# HAVEN VALLEY

**PRELIMINARY GRADING PLAN**

# GP01

# Grading & Erosion Control Plan\_v4.pdf Markup Summary 5-9-2022

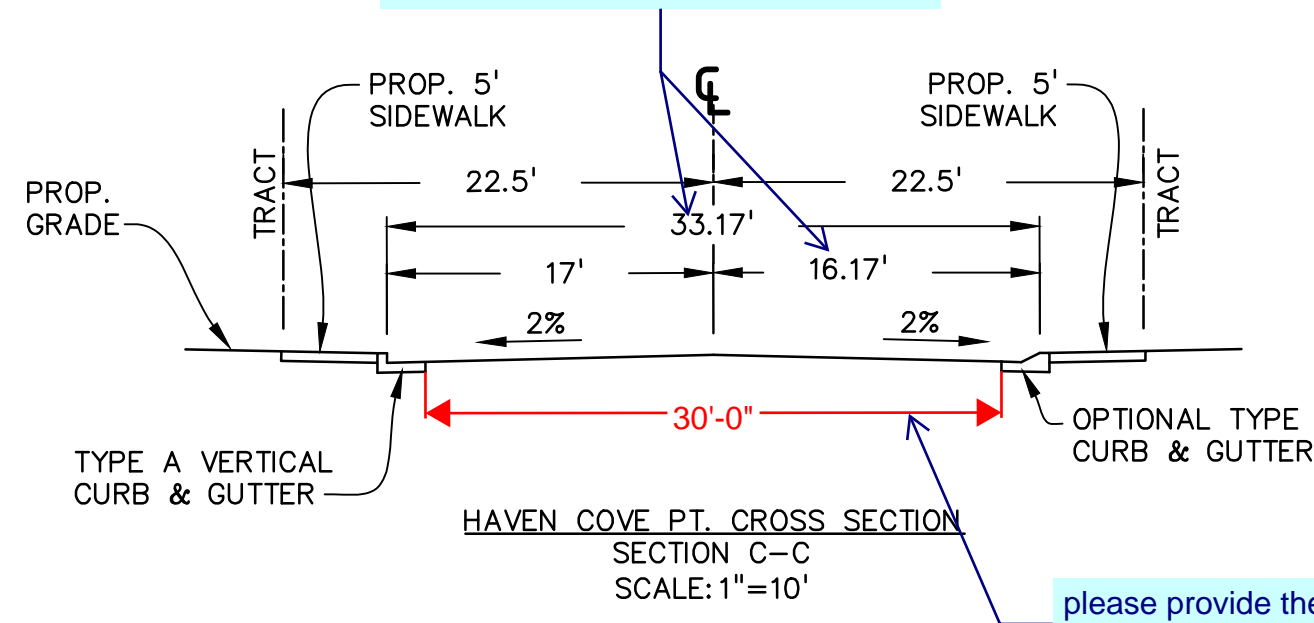
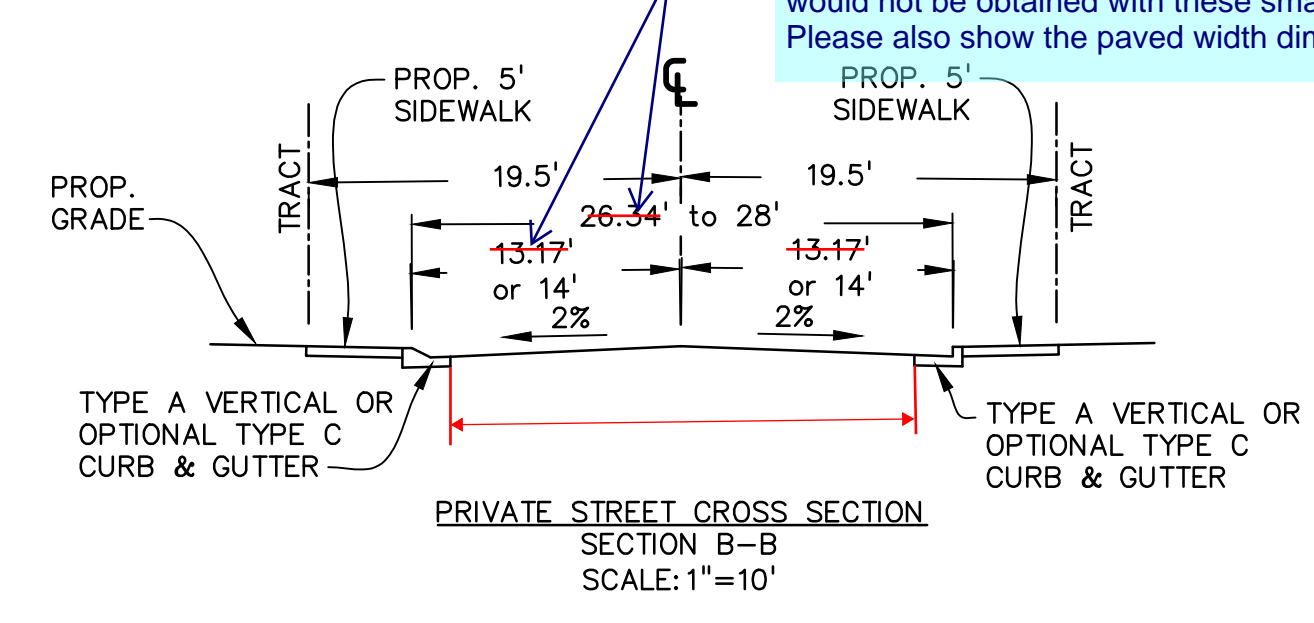
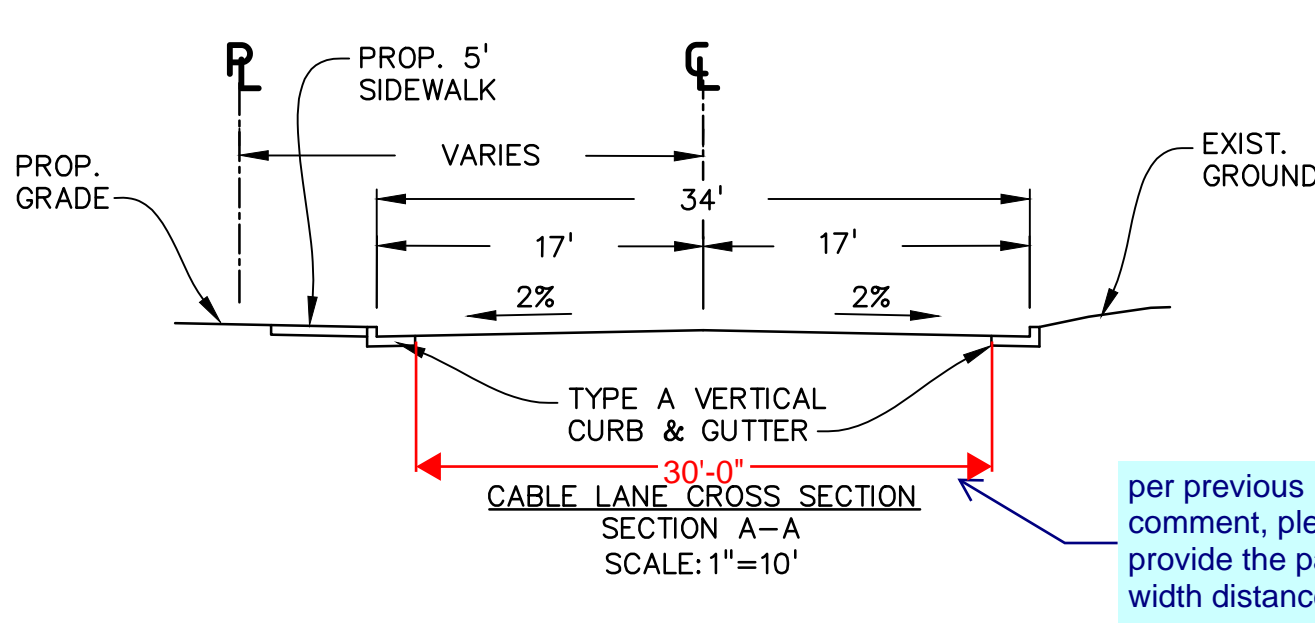
Please remove the distance shown. The smallest roadway per the PUD and TIS is an urban local low volume roadway which will have a minimum 24' paved width which would not be obtained with these smaller distances. Please also show the paved width dimension.

please revise the distance such that it meets the urban local roadway standards (17.5' to back of curb and 30' min. paved width)

Recommend showing the distance on the cross sections to the back of curb to be consistent with the sections on the PUD plan and for clarity.

per previous comment, please provide the paved width distance.

please provide the paved width distance
